## MANUFACTURED HOUSING CONSENSUS COMMITTEE

# MHCC Proposed Changes

## 2024-2025 Cycle

January 4, 2024

### Example of typical garage placement:

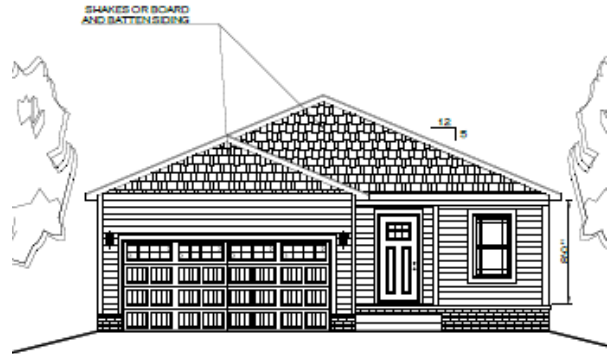
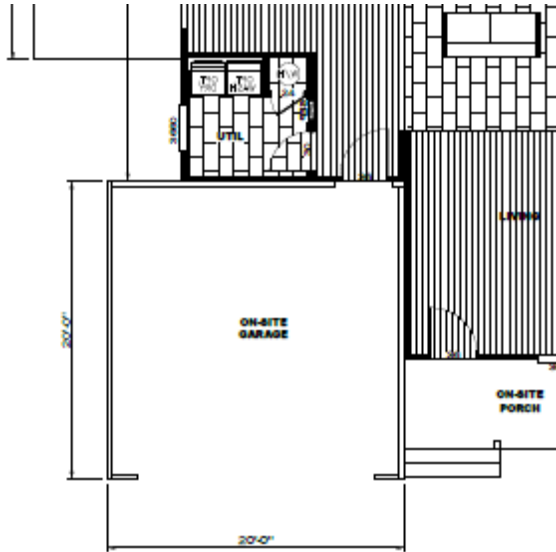
3. **Reason:** Garages are often inset into floor plans in a manner that would require separation gypsum to extend in areas where there are not vertical framing members for attachment (see attached example). Allowing the separation gypsum to terminate at ½” gypsum garage ceiling will often save time and construction cost. Current regulation does not recognize this commonly used and accepted method in IRC. Since garages are typically constructed on-site many builders are accustom at stopping separation wall at the garage ceiling in conformance with IRC and locally approved practice and therefore the addition of the proposed sentence better align with national recognized code and reduce failed Site Completion inspections.

4. **Substantiation:** The International Residential Code (IRC) allows garage to dwelling separation to stop either at roof decking or at ½” gypsum garage ceiling. Adding the proposed sentence would better align with IRC requirements which are nationally recognized (see attached R302.6 from 2021 IRC).

(1) The garage must be separated from the manufactured home and its attic by not less than ½ -inch gypsum board or equivalent applied to the garage side of the manufactured home, separation shall be from the underside of the floor to the underside of the roof deck and may be provided on-site as part of an On-Site Completion of Construction approval. Separation may stop at ½-inch gypsum garage ceiling when interior of garage is completely enclosed by ½- inch gypsum or equivalent. Garages beneath habitable rooms must be separated from all habitable rooms by 5/8 - inch, Type X gypsum board or equivalent. Where the separation is a floor ceiling assembly, the structure supporting the separation must also be protected by not less than ½ -inch gypsum board or equivalent. The design approval and the manufacturer's installation instructions must also include provision for equivalent vertical or horizontal separation between the garage and the manufactured home as appropriate.
